Bulletin No.: PIT5757

### PIT5757 Front License Plate Bracket Does Not Fit Correctly To The Fascia

Brand:	Model:	Model Years:	VIN:		Engine:	Transmissions:
			from	to		
GMC	Yukon Models	2021	All	All	All	All

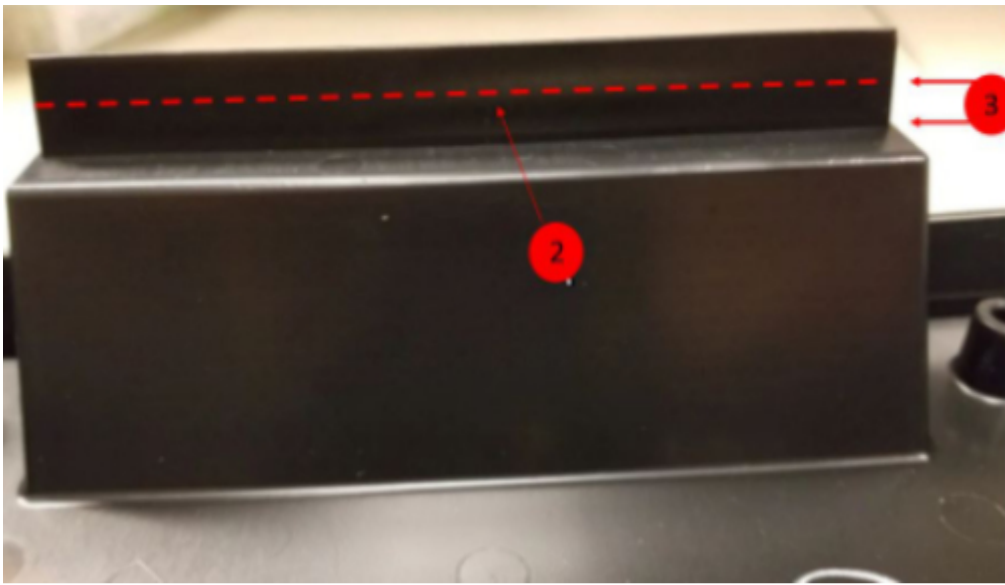
Involved Region or Country	North America
Condition	Some dealerships may notice the front license plate/tag bracket does not fit or mount properly to the front fascia.
Cause	This concern could be caused by the license plate bracket flange (1) incorrectly molded and is too long.

To correct this concern modify the license plate bracket flange (1) as shown below.

1. Mark a line (2) along the flange a distance of 8.6 mm from the body of the bracket (3).
2. Using a suitable tool cut off the flange along the marked line.

3. When finished the flange will be approximately half its original length (4).
4. Install the license plate bracket to the fascia.
